**ADDENDUM NO. 2
TO THE
CONTRACT DOCUMENTS AND SPECIFICATIONS
FOR
NEW SIDEWALK CONSTRUCTION BETWEEN US 98 AND CR 13 ON CR 44 AND
MANLEY ROAD
ALDOT PROJECT NO. TAPOA-TA17(937)
CITY BID NO. 028-19, CITY PROJECT NO. PW021-17**

**TAPOA-TA17(937) FAIRHOPE 2017 TAP NEW SIDEWALK
BETWEEN US 98 AND CR13**

RESPONSIBLE PE:	SUPERVISOR:	DESIGNER:	PLAN SUBMITTAL:	CITY OF FAIRHOPE	NOT TO SCALE	SHEET TITLE	ROUTE
DATE:	DATE:	DATE:				PROJECT DETAILS	CR 44

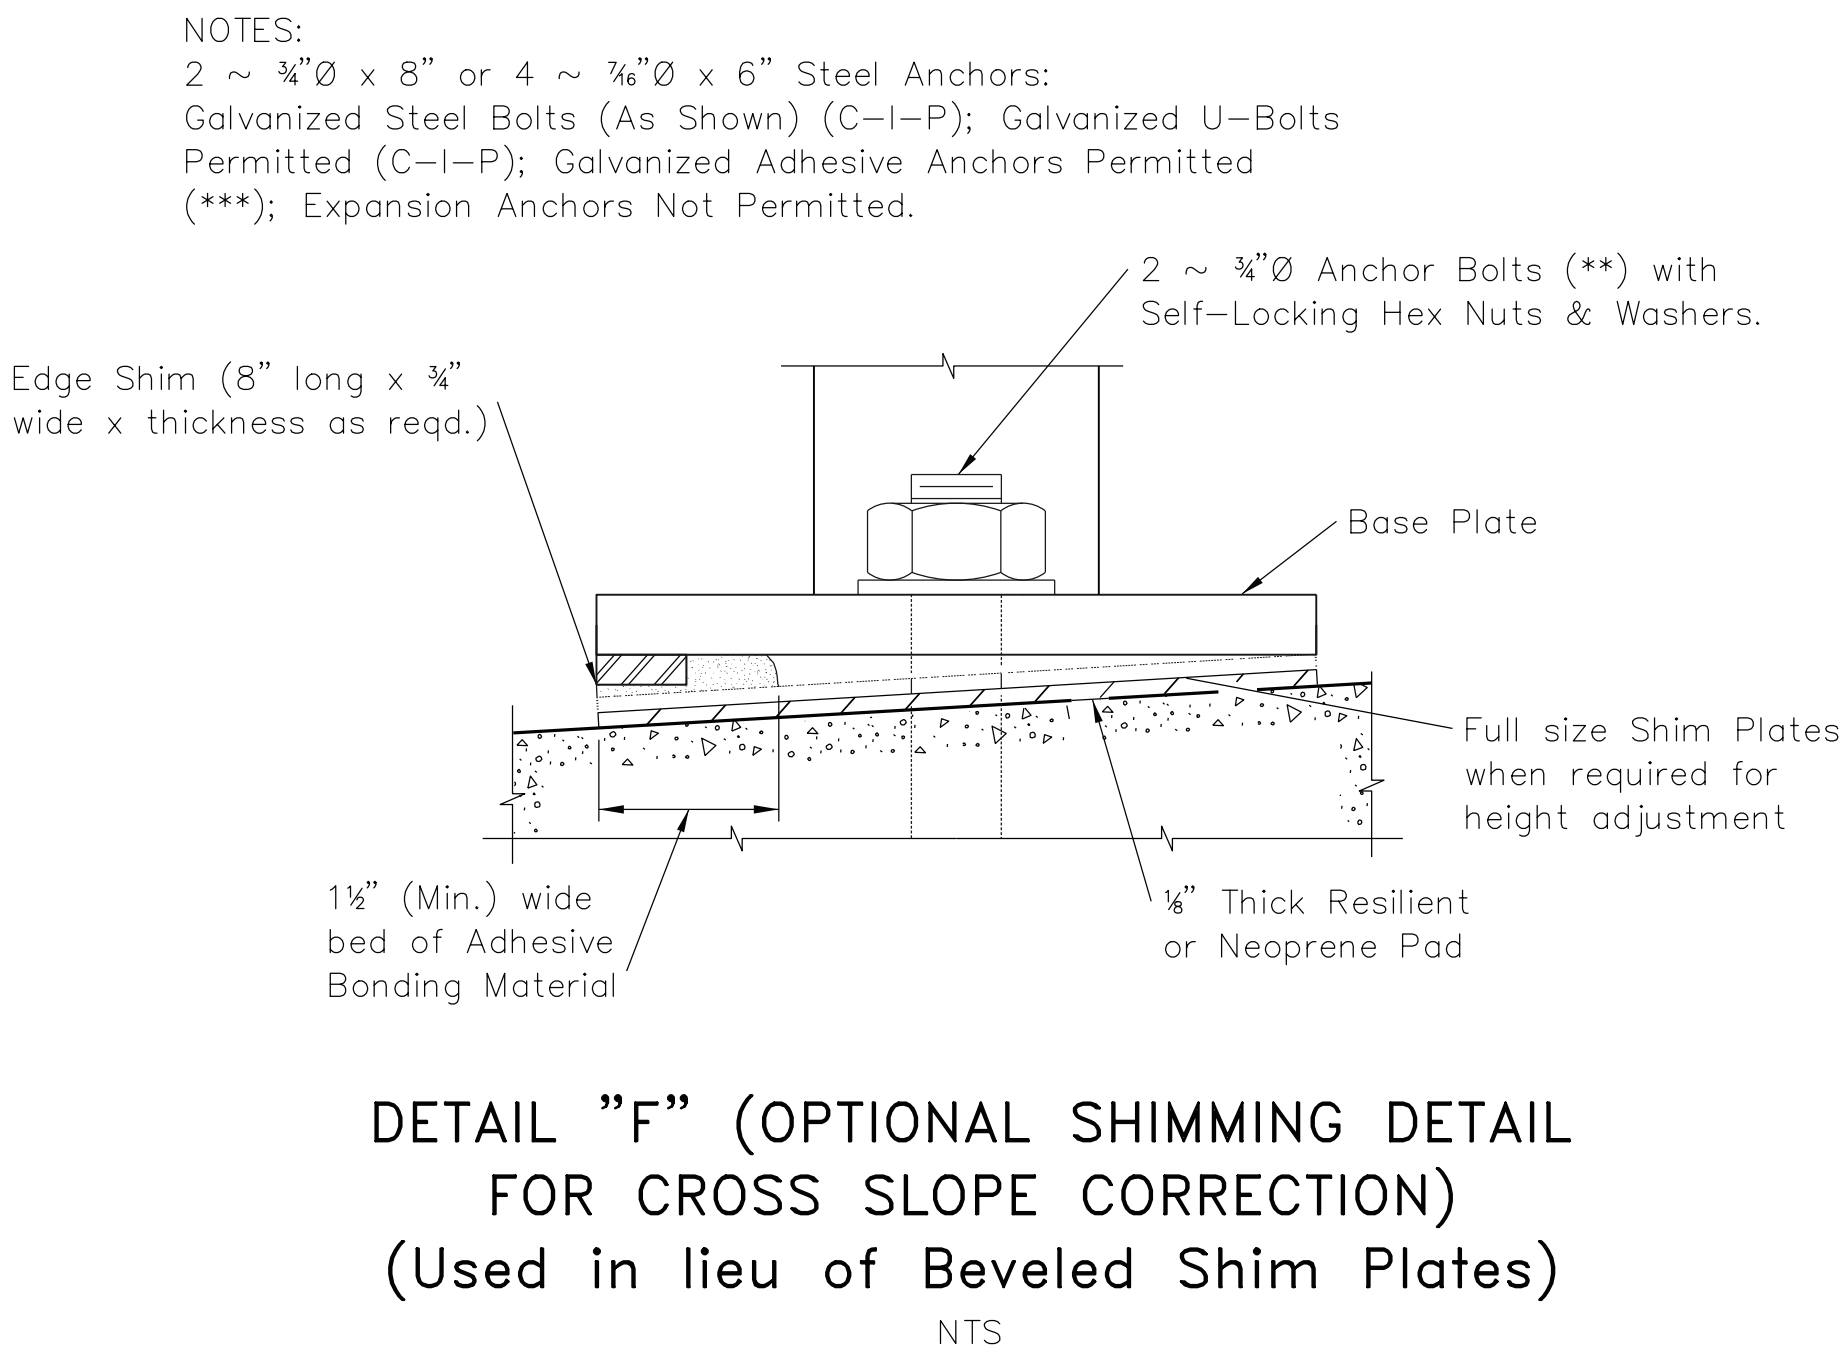
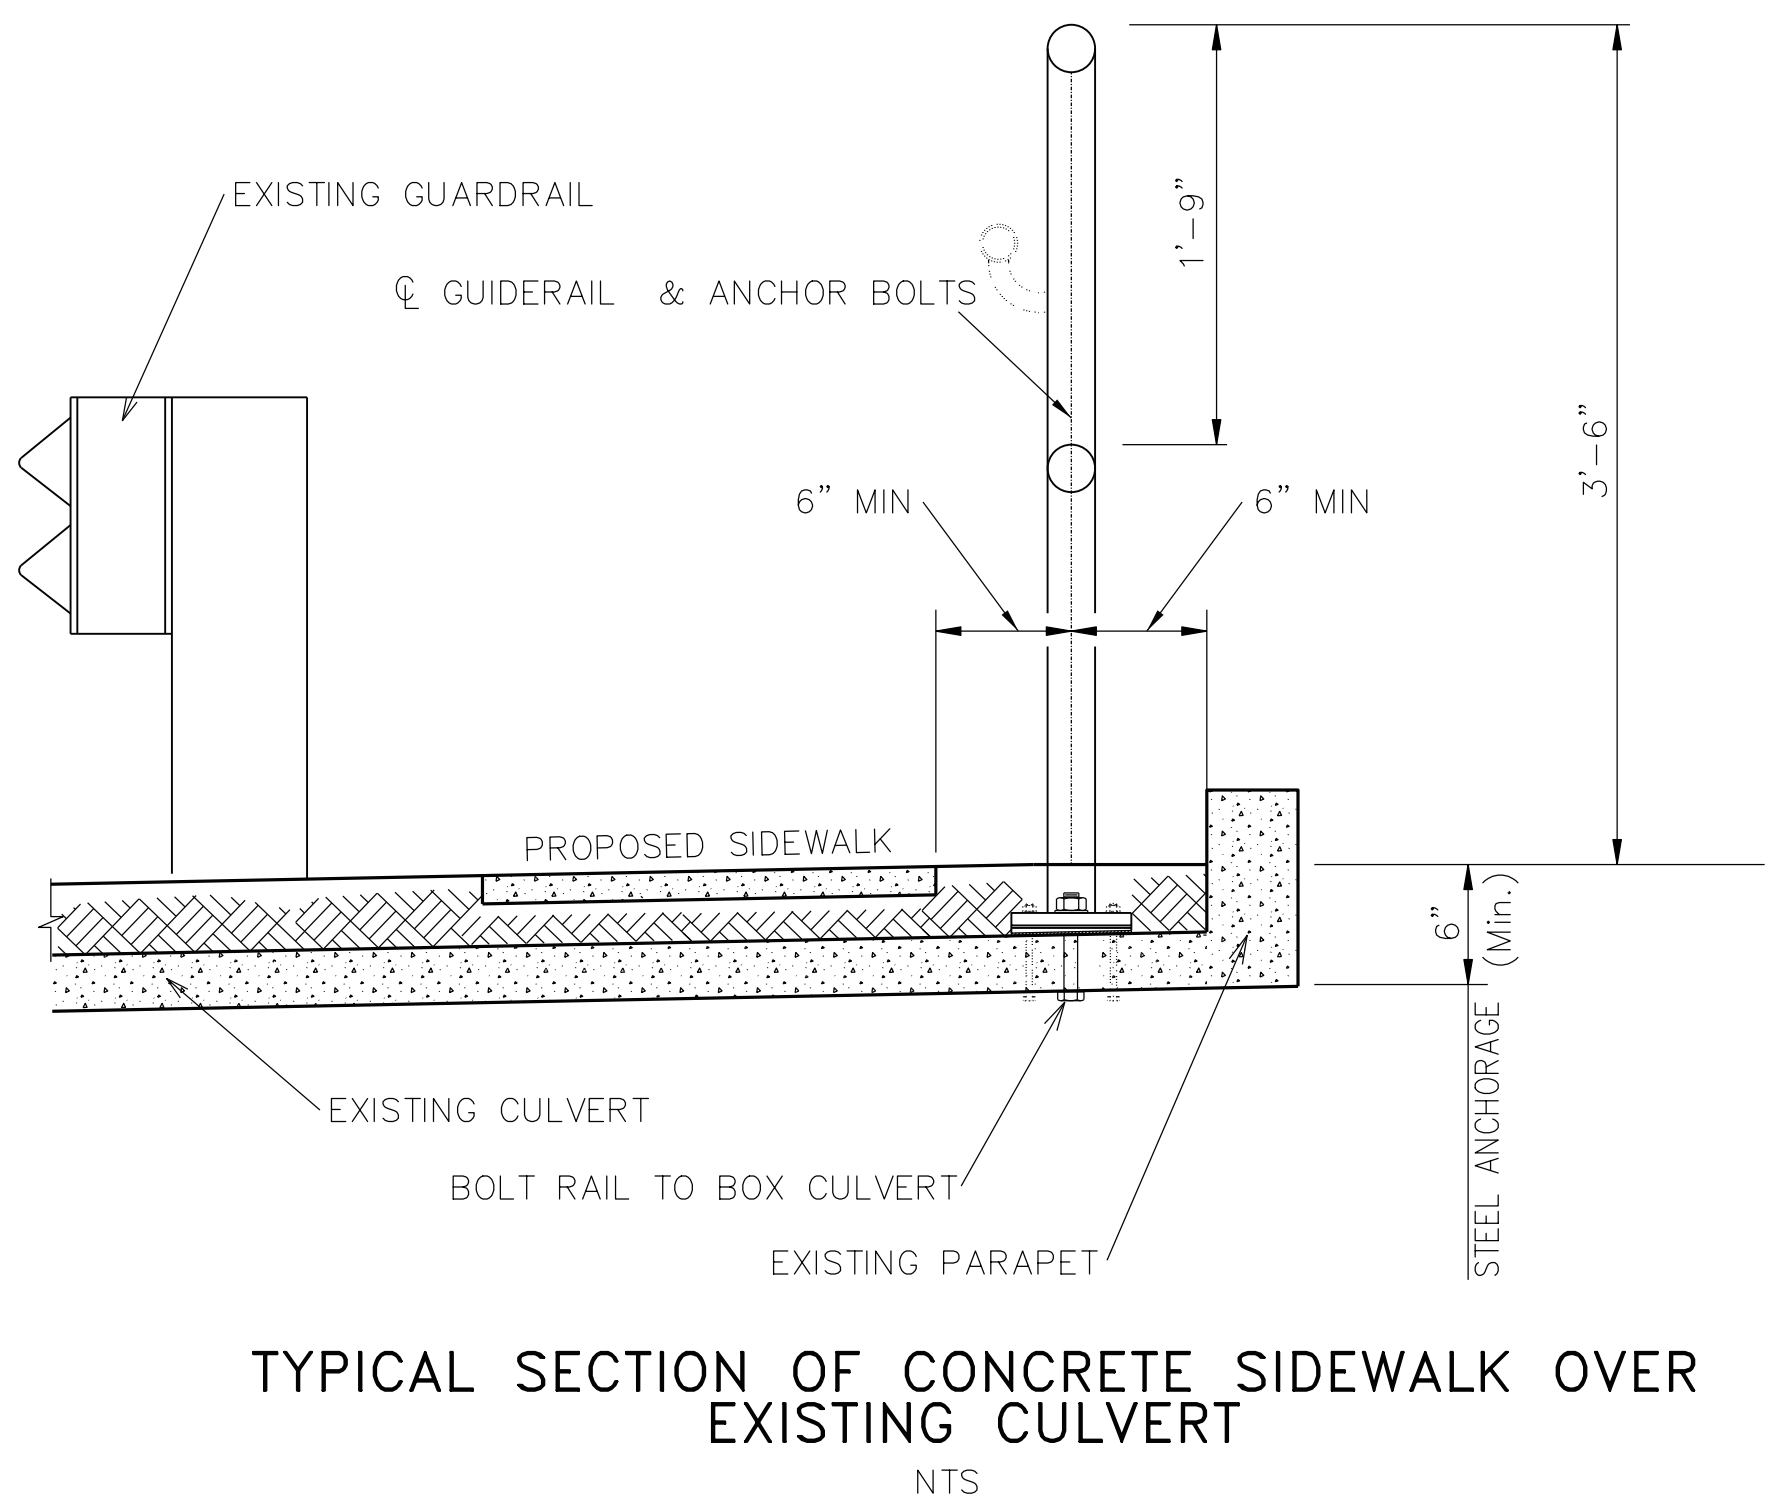
- A. Plan Details, Sheet 2E shall be replaced with the sheet attached.**
- a. Details for both the "Turn-Up" and Turndown detail have been revised to add steel reinforcement requirements. Estimates for both steel and minor structure concrete have also been added.
- B. Summary of Quantities, Sheet 3 Shall be revised as follows:**
- a. Item 614A-000, Slope Paving has been deleted.
 - b. Item 618A-000, Sidewalk, 4" Thick has been revised to 2,715 Square Yards.
 - c. Item 620A-000, has been revised to 98 Cubic Yards.
- C. Summary of Quantities, Sheet 3A Shall be revised as follows:**
- a. Item 614A-000, Slope Paving has been deleted.
 - b. Item 618A-000, Sidewalk, 4" Thick has been revised to 2,715 Square Yards.
 - c. Item 620A-000, has been revised to 98 Cubic Yards.
